LUPIN MINES INCORPORATED
(A Wholly Owned Indirect Subsidiary of Mandalay Resources Corp.)

Re: LMI Final Submission (2AM-LUP1520)

2018 Application for Water Licence Renewal/Amendment, and Final Closure and Reclamation Plan

ATTACHMENT 1 – CONTINGENCY CONTAMINANTS MANAGEMENT DECISION MATRIX (REFER TO CIRNAC INITIAL SUBMISSION NO.8)

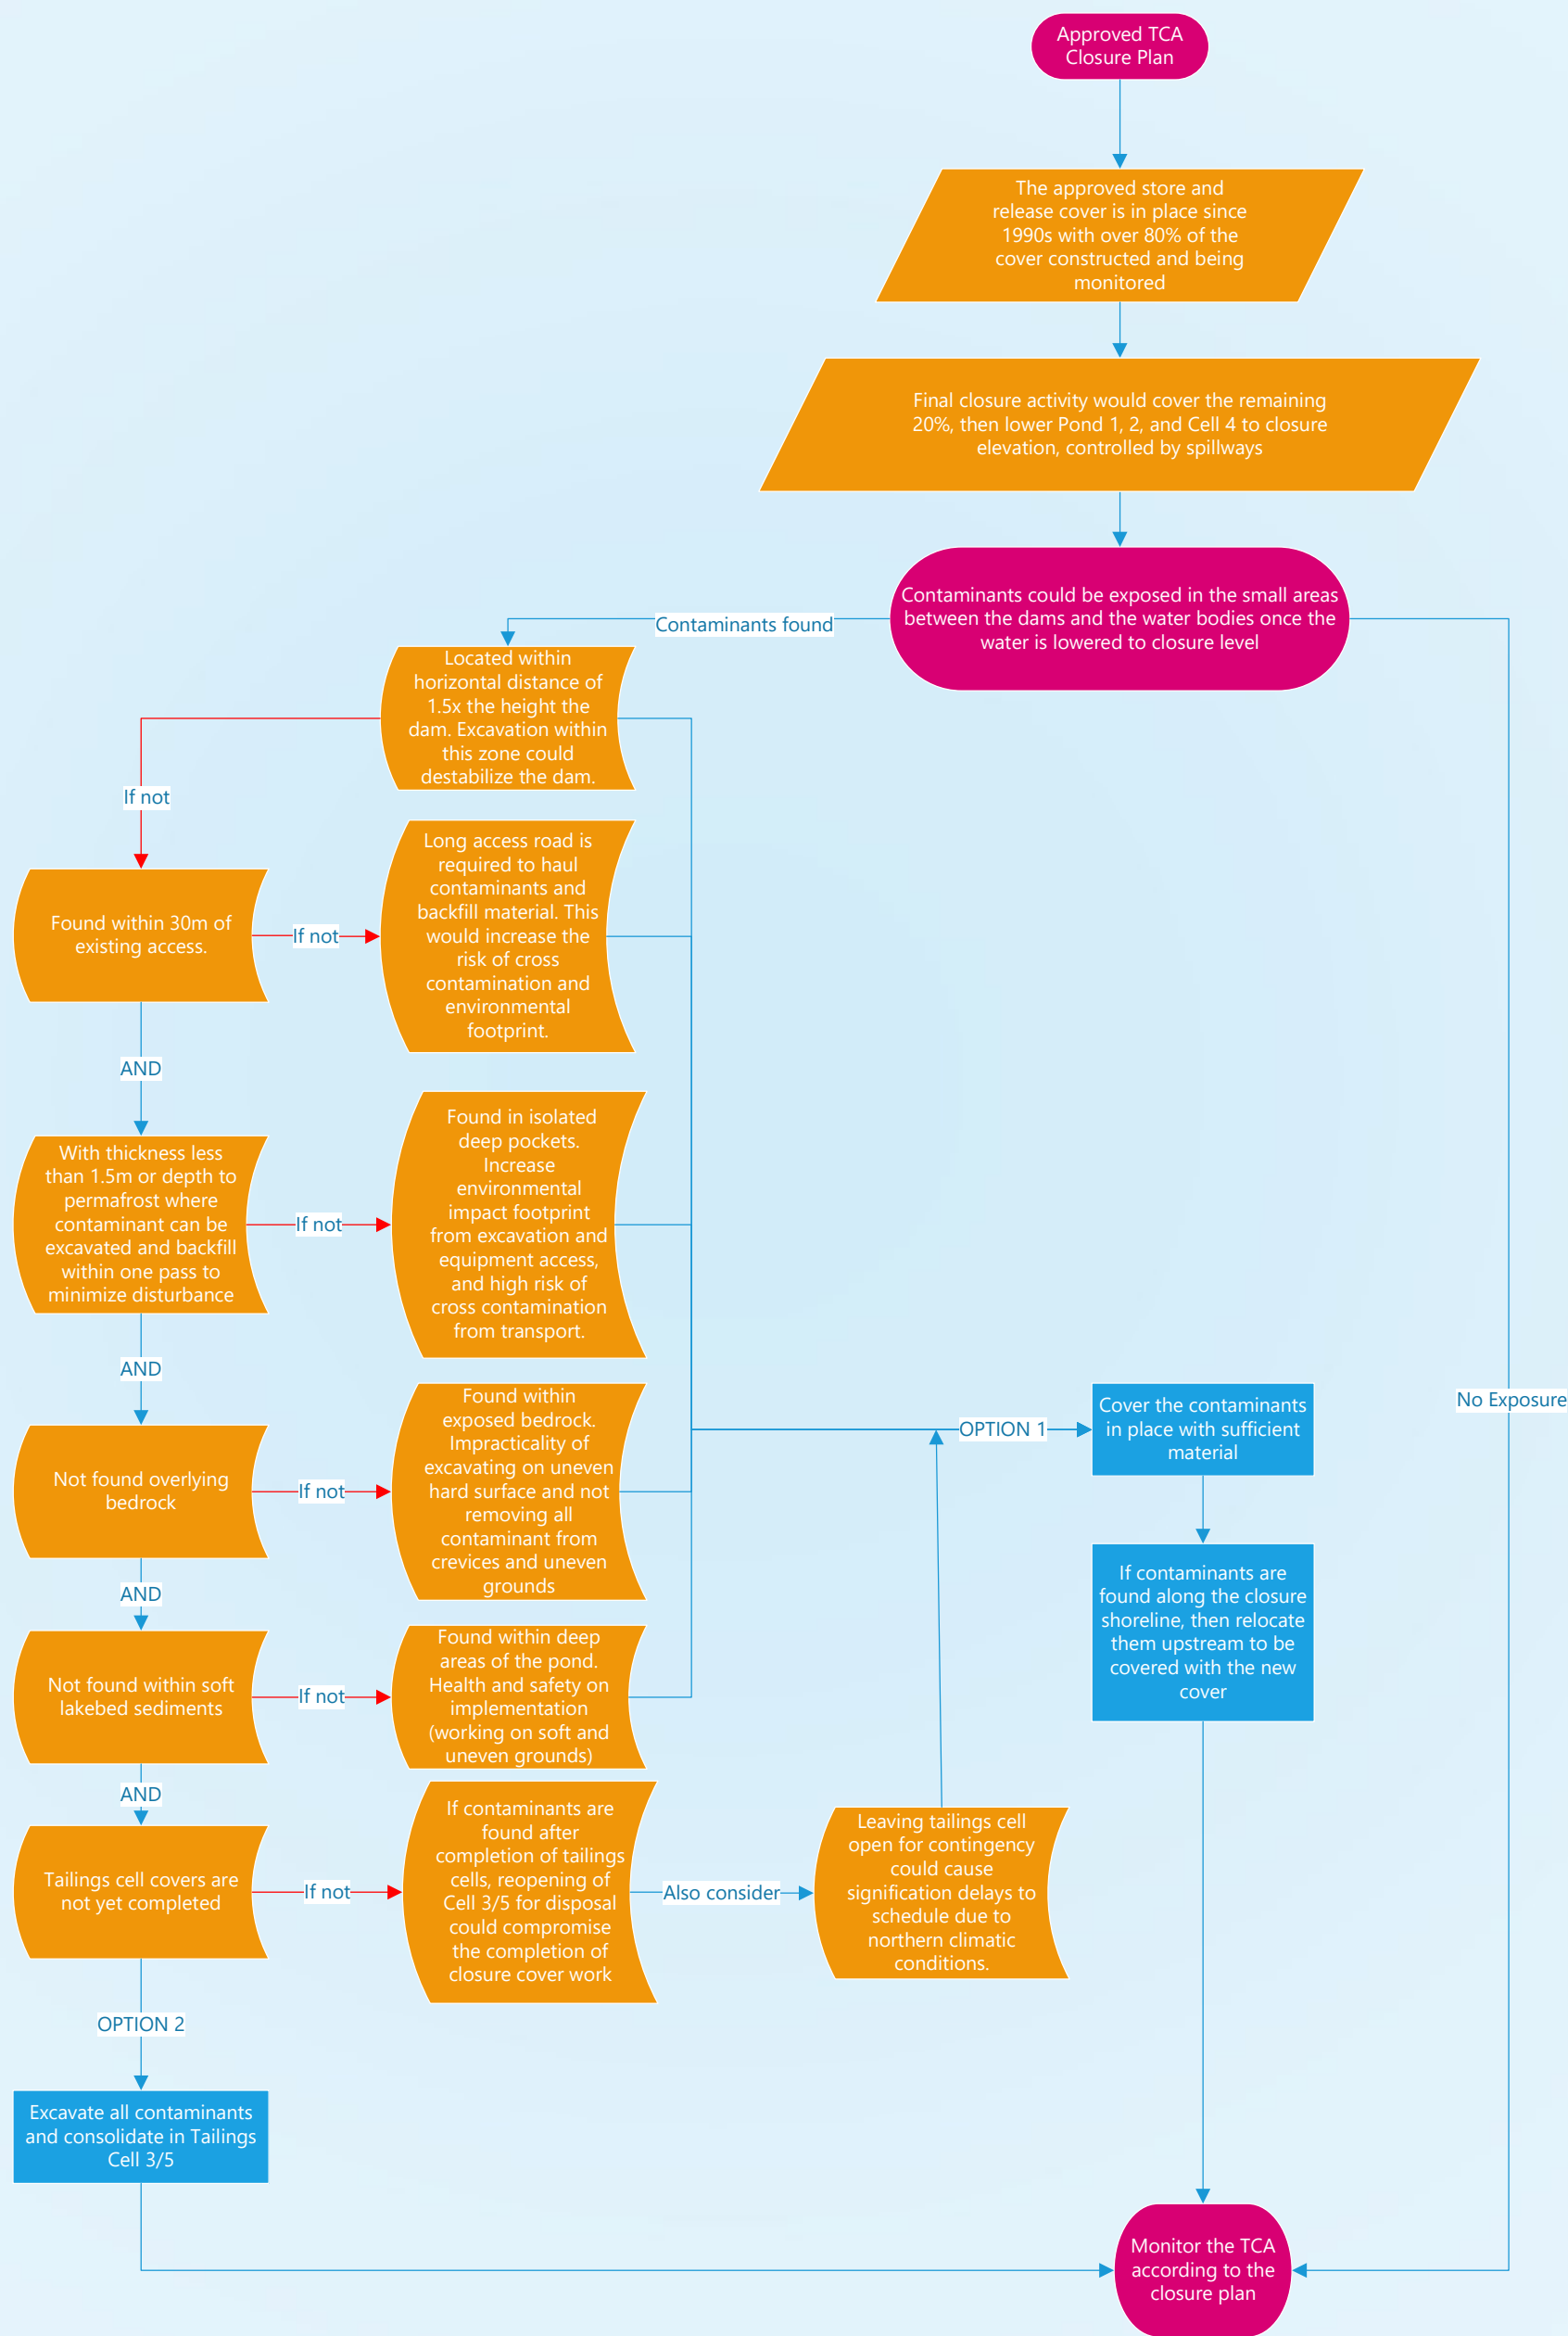
In CIRNAC's view, the information provided in the Stantec memo, dated October 15, 2019 does not provide a "decision matrix" for how it would be decided as to whether or not, on a case by case basis in the field, exposed tailings would be left in place or removed and placed within the tailings cell.

It is CIRNAC's opinion that no material amount of tailings should remain outside of the defined containment cells at closure. Placement of 1m esker cover on any exposed tailings within the dewatered former pond areas, will not be effective in reducing ARD/ML from these tailings and result in impacted seepage from these areas. It is recommended that LMI provide an adaptive management decision matrix clearly outlining how the potentially exposed tailings would be managed.

The presented information is a contingency decision matrix to be used if exposed contaminants are encountered after the ponds are lowered to the closure levels. At this time there is no indication that contaminants or tailings will be exposed after the water levels are lowered. The currently approved Closure Plan for the Tailings Containment Area (Kinross 2005) uses an esker cover to reduce ARD/ML potential from placed tailings. In addition, subsequent to the TCA closure plan's approval, a TCA ecological risk assessment was conducted in 2004 (Golder 2004) and determined that covering the exposed tailings with esker sand is effective in mitigating offsite environmental impacts and was approved under the water licence renewal in 2016.

The contingency decision matrix was requested by CIRNAC and uses an engineering risk-based approach to determine how potentially exposed contaminants will be handled on a case by case basis. The contingency decision matrix provides the mechanism to mitigate the risks to the environment from exposed contaminants by either covering in place with sufficient esker sand materials (Option 1) or excavating the contaminants and consolidating them in Tailings Cells 3 and/or 5 (Option 2). Monitoring data from the TCA, collected and monitored over the last 25-30 years, and reconfirmed in response to Commitment No. 10, indicates that covering in place is an effective method of reducing the risk of ARD/ML.
